# ADDENDUM NO. 1

May 22, 2008

## SCHNEIDER PUMP STATION ELIMINATION PROJECT NORTH RIDGEVILLE, OHIO

### PLANS Sheet 3 of 5

#### CONSTRUCTION SEQUENCE FOR INSTALLATION OF SEWER

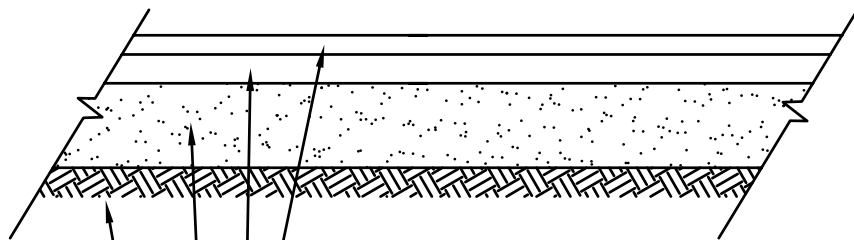
6. The Construction Sequence shall be replaced with the following:

1. BORE UNDER EXISTING AVON BELDEN PAVEMENT.
2. INSTALL ALL 12" TO WITHIN 5 FEET OF THE EXISTING MANHOLES ON THE EXISTING SEWER.
3. CAP OR PLUG ENDS OF THE NEW PIPES.
4. TEST ALL INSTALLED MANHOLES AND SEWERS.
5. INSTALL THE FLOW METER IN MANHOLE #56.
6. REMOVE EXISTING MANHOLES # 58 AND #59, CONSTRUCT THE NEW MANHOLE #59 AND CONNECT THE EXISTING SEWERS TO THE PROPOSED SEWERS. THE SEWAGE FROM THE EXISTING SEWERS MAY HAVE TO BE PUMPED AROUND THE MANHOLES WHILE THE EXISTING SEWERS ARE BEING CONNECTED TO THE PROPOSED SEWERS.
7. WASH DOWN THE WET WELL AND PUMP THE WASH WATER THROUGH THE FORCE MAIN. ABANDON, PLUG, OR REMOVE ALL APPURTENANT ITEMS IN ORDER TO TAKE THE PUMP STATION OUT OF ORDER.
